COMMENTS WITH REGARDS TO THE PROPOSED AMENDED LAYOUT OF THE RICHARDS BAY COMBINED CYCLE (CCPP) POWER PLANT AND ASSOCIATED INFRASTRUCTURE NEAR RICHARDS BAY, KWAZULU-NATAL PROVINCE (REF NR: SE1655)

RE: COMMENTS WITH REGARDS TO THE AMENDED LAYOUT PROPOSED FOR THE RICHARDS BAY COMBINED CYCLE (CCPP) POWER PLANT AND ASSOCIATED INFRASTRUCTURE NEAR RICHARDS BAY, KWAZULU-NATAL PROVINCE (REF NR: SE1655)

PROPOSED RICHARDS BAY COMBINED CYCLE POWER PLANT (CCPP) PROJECT IN RICHARDS BAY, KWAZULU-NATAL PROVINCE - REVIEW OF VISUAL IMPLICATIONS OF PROPOSED LAYOUT AMENDMENTS DETAILED ON SITE LAYOUT DRAWING 0.103/00010 REV 2

**ADDENDUM TO THE QUANTITATIVE RISK
ASSESSMENT FOR THE PROPOSED RICHARDS
BAY COMBINED CYCLE POWER PLANT NEAR
RICHARDS BAY, KWAZULU-NATAL PROVINCE**

Figure 1: The extent of the wetland ecosystem on the project site in relation to the amended layout.

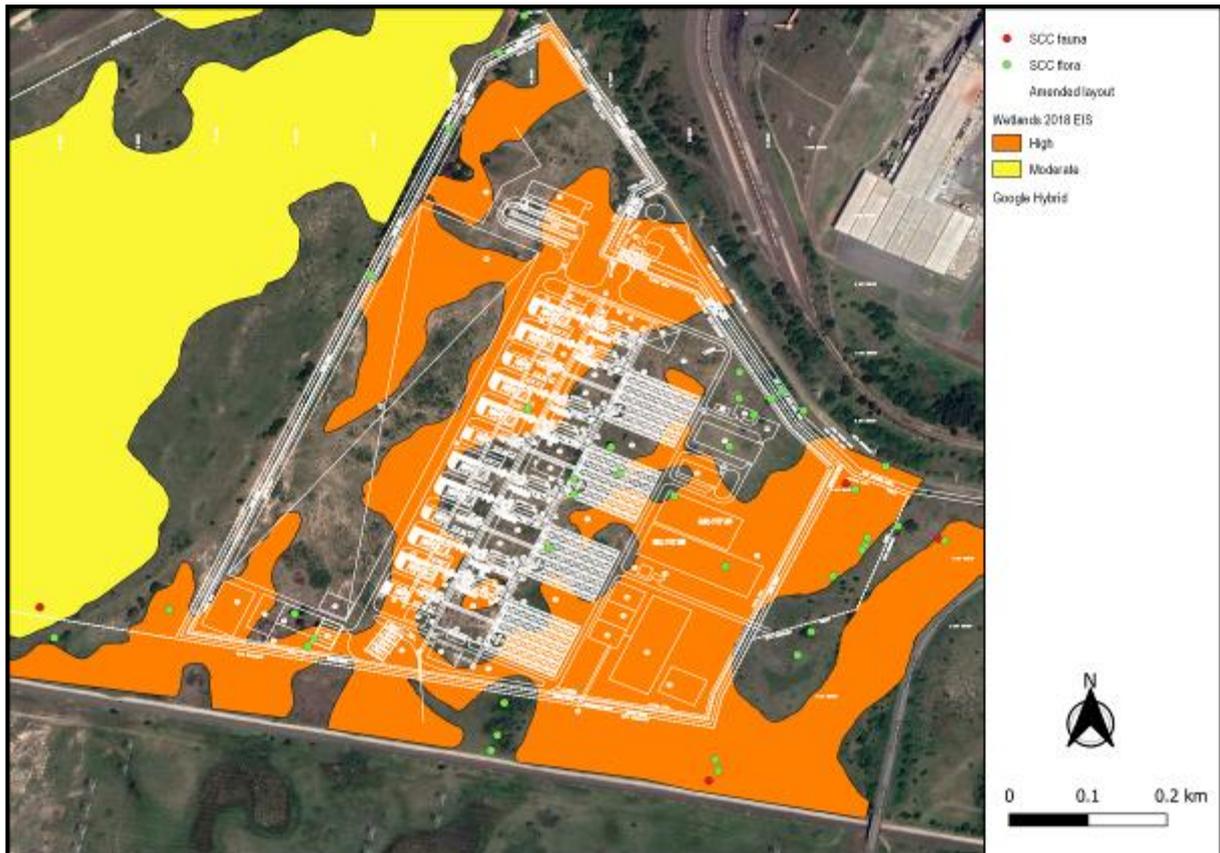
Due to the extent of the proposed project activities, the wetland ecosystems as delineated by 'The Biodiversity Company' and considered in the Ecological Impact Assessment Report covers large areas on the project site (Figure 1). Although it is conceded that the development footprint was reduced on the amended layout, drainage of the wetlands will still be required to accommodate infrastructure. Consequently the loss of wetland ecosystems will be unavoidable. Since the wetland ecosystem on the project site provide habitat to three wetland dependent fauna species of conservation significance, i.e. *Hemisus guttatus* (Vulnerable), *Crocidura mariquensis* (Near Threatened) and *Hyperolius microps* (Range Restricted), the implementation of the wetland offset plan as proposed in the Environmental Impact Assessment Report of March 2019 will still be relevant.

APPENDIX A – AMENDED LAYOUT

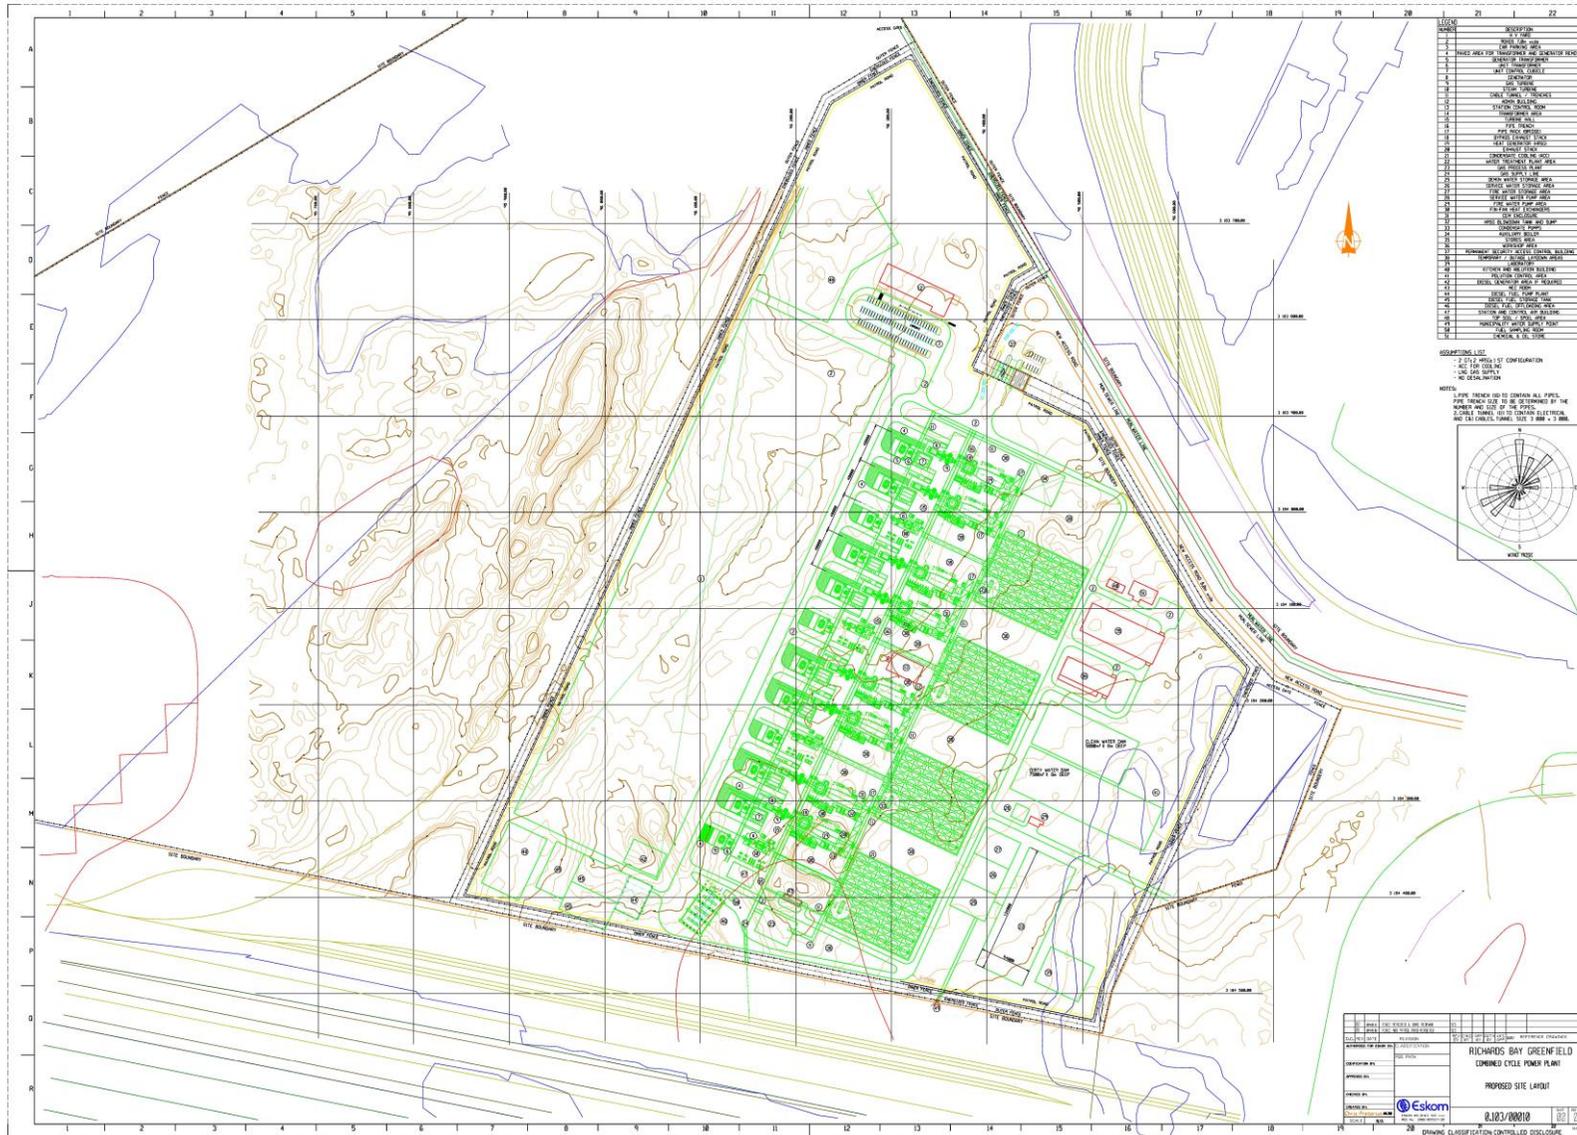
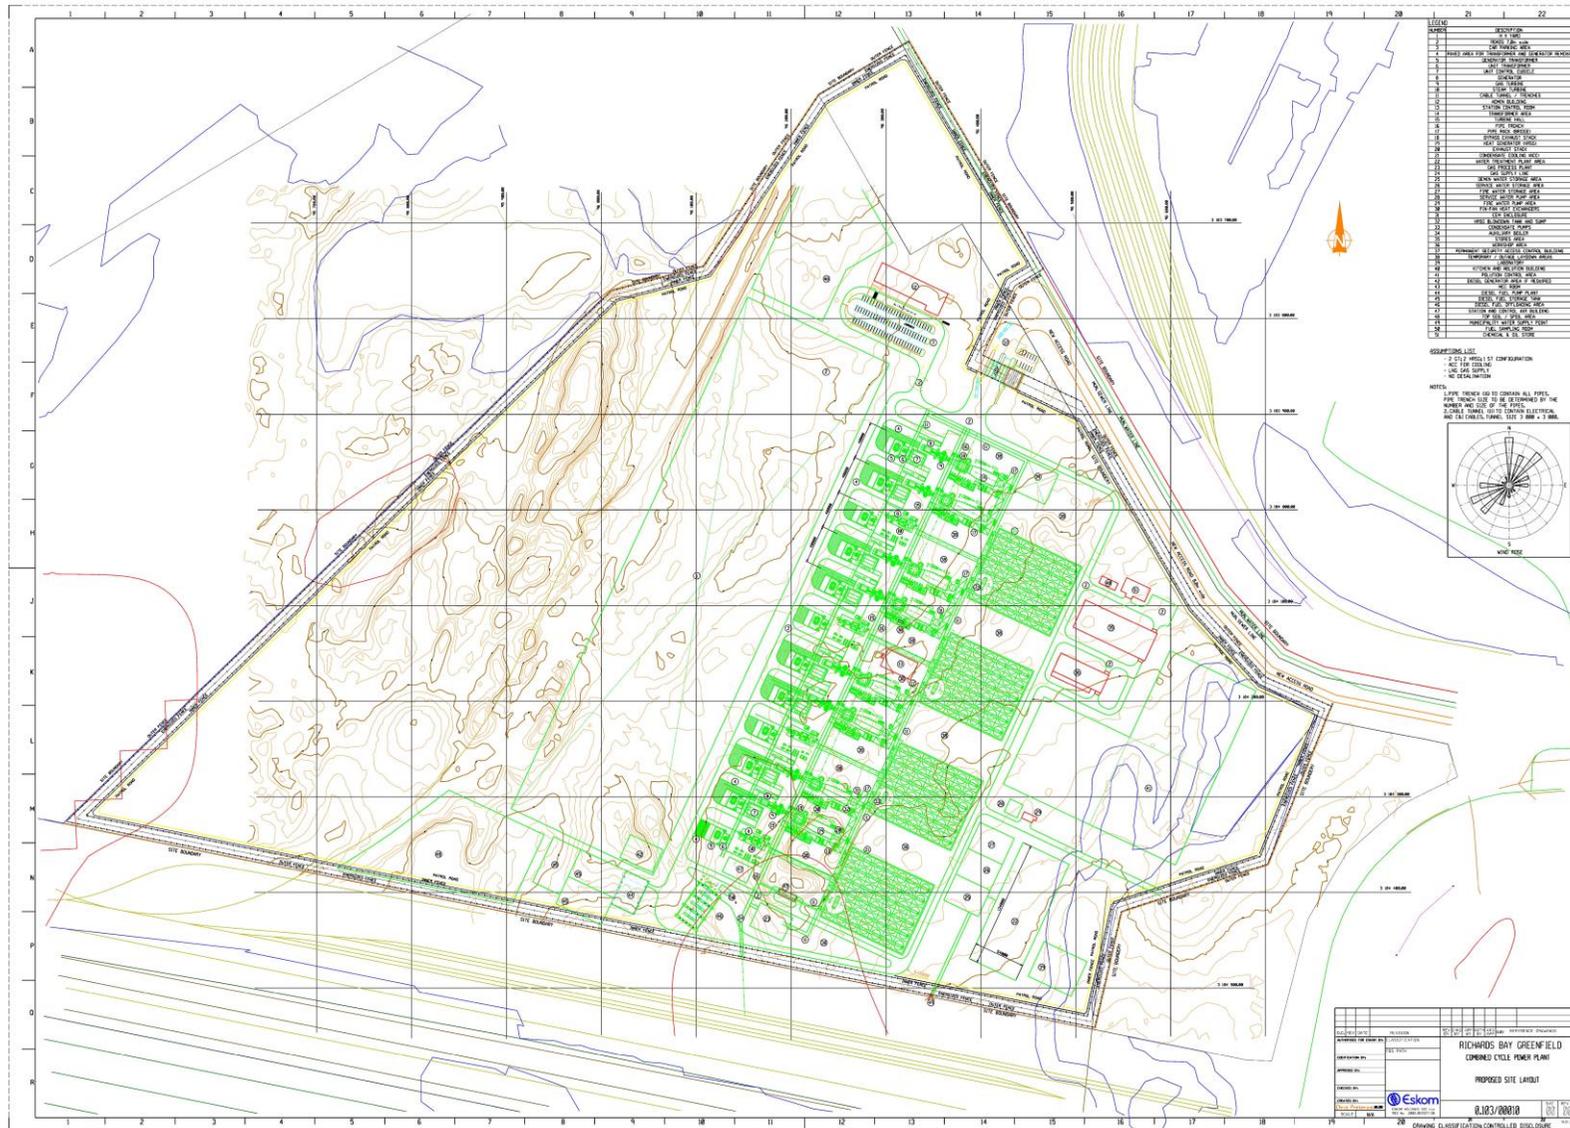
Thank you for forwarding the proposed layout changes (i.e. amended layout, refer to Appendix A) for the Richards Bay Combined Cycle (CCPP) power plant and associated infrastructure to me on the 17th of May 2019. The following changes to the layout are noted:

- The original layout assessed as part of the impact assessment report represented a development footprint of 71ha. The development footprint has been reduced to 52ha as part of the amended layout;
- The western and eastern boundaries of the development footprint have been reduced;
- The western boundary of the development footprint is now located parallel to the Transmission HV yard;
- The extent of the top-soil laydown area has been reduced; and
- The pollution control area has been reduced.

Having considered the effects this proposed change will have on the impacts/mitigation initially identified as per the original layout assessed (Appendix B) as part of the ecological impact assessment, there will be no change with regards to the ecological impacts identified for the construction and operation phases on the receiving environment. The impacts assessed are described below.

The mitigation measures proposed in the Ecological Impact Assessment report for the above mentioned impacts are regarded as sufficient and no additional mitigation measures are required.

APPENDIX A – AMENDED LAYOUT

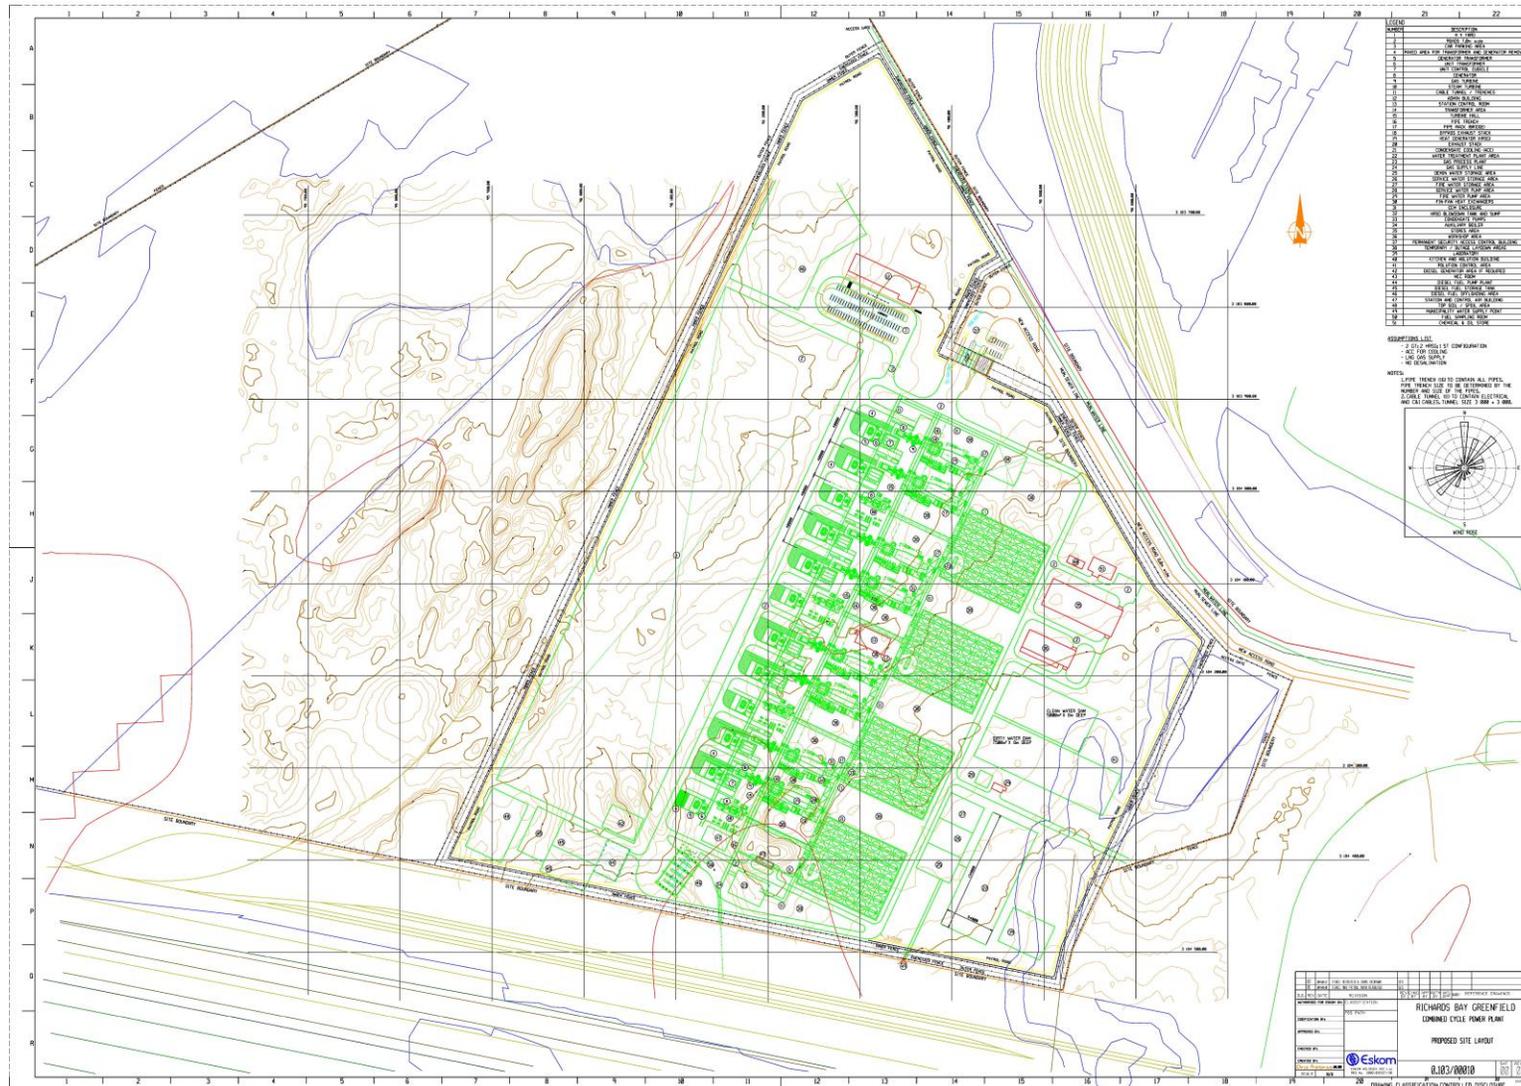
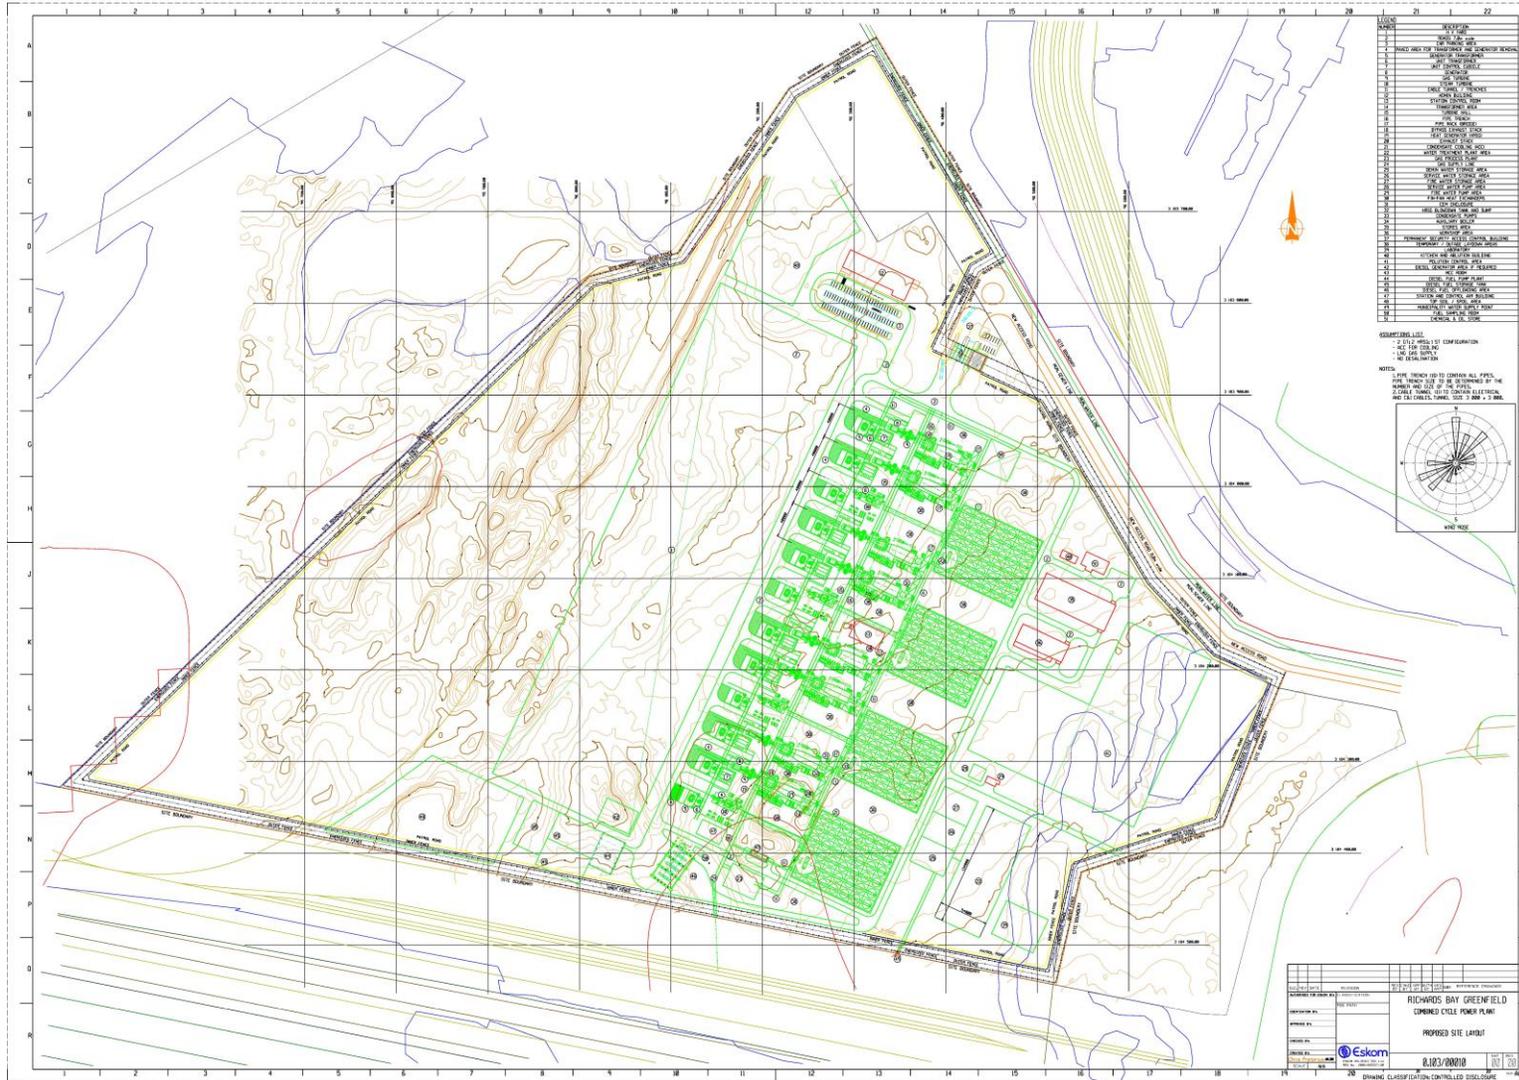
Having considered the proposed amended layout (Appendix A), the impacts/mitigation identified and prescribed in the original layout (Appendix B) remain and there will be no change with regards to the impacts on the receiving environment with the implementation of the amended layout. The impacts assessed are described below.

The original layout resulted in the loss of 10.49 ha Namib soil form and Class III Land Capability, which was reduced by 0.21 ha due to the amended layout. The loss of the remaining soil forms (e.g. Longlands, Katspruit etc.) and Land Capability classes (e.g. Class IV and Class V etc.) remains similar for both layouts, 0.45 ha and 25.7 ha respectively. This is based on direct impacts only, and taking into considering likely indirect impacts to the soils / agricultural potential for the area there is not notable difference in the level of impact significance between the two options.

The mitigation measures and recommendations prescribed in the Agricultural Potential Impact Assessment report are regarded as sufficient and no amendments or additions to the recommendations or results are required for the implementation of the amended layout.

Figure 2: Amended layout

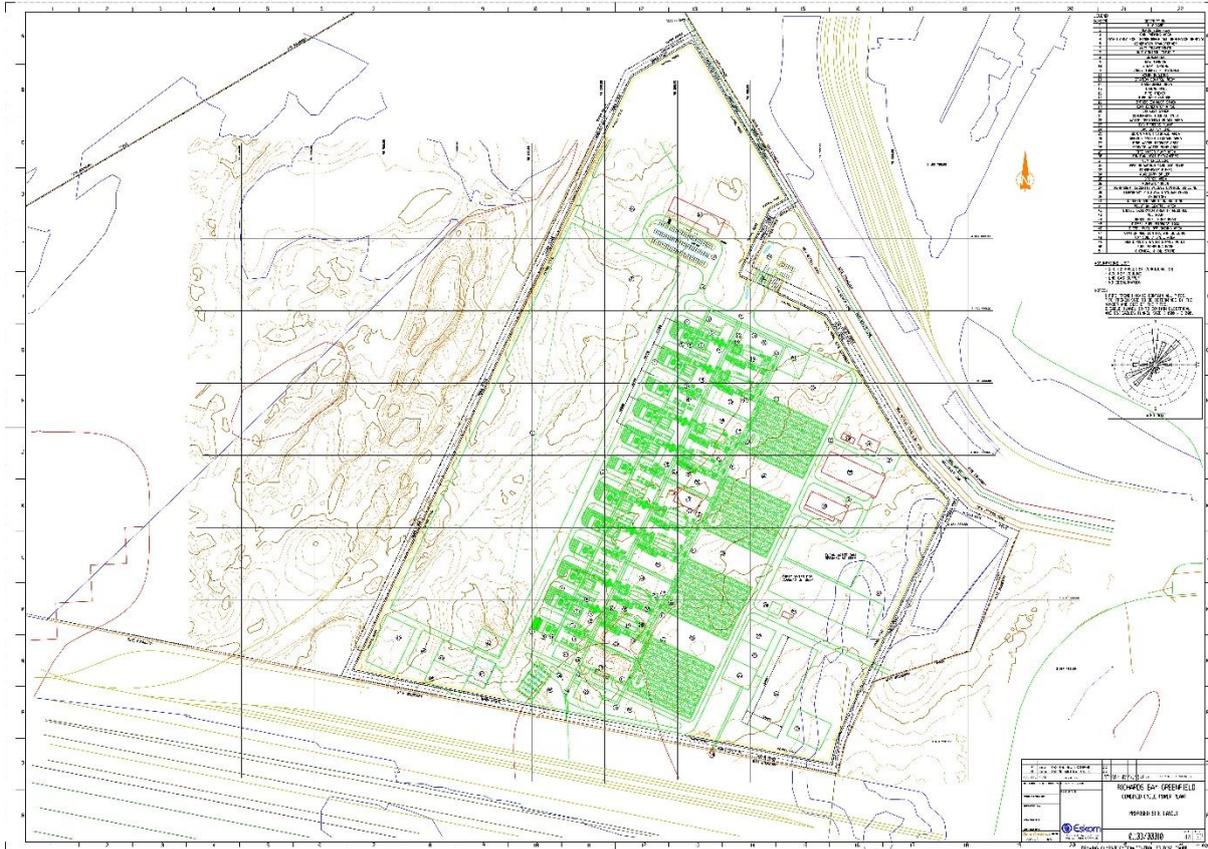
The amended site layout was provided by Eskom (via Savannah Environmental on 17 May 2019). The original location (Appendix A - Figure 1) of the sources of atmospheric pollutant emissions, as assessed in the Atmospheric Impact Report as part of the EIA process, were compared with the amended site layout (Appendix B - Figure 2). The locations differ by 20 m or less between the two layouts. The sources are now slightly further away from the nearest receptors. The finest grid resolution used in the CALPUFF dispersion model setup was 50 m for a 2.5 km x 2.5 km area, centred over the proposed facility.

Since the difference in source locations is smaller than the finest grid resolution of the dispersion model, the amended locations of the sources of atmospheric pollutant emissions, based on the amended layout, are not likely to result in a substantive change in impact area from that summarised in the AIR. Remodelling using the amended layout is not required. The potential pollutant concentrations at the receptors could stay the same or decrease. The mitigation measures included in the Atmospheric Impact Report (as part of the EIA process) are sufficient for the implementation of the amended layout and that no additional measures will be required. The “medium” significance rating of the SO₂ impacts, and “low” significance rating of other pollutants released during operation will still apply.
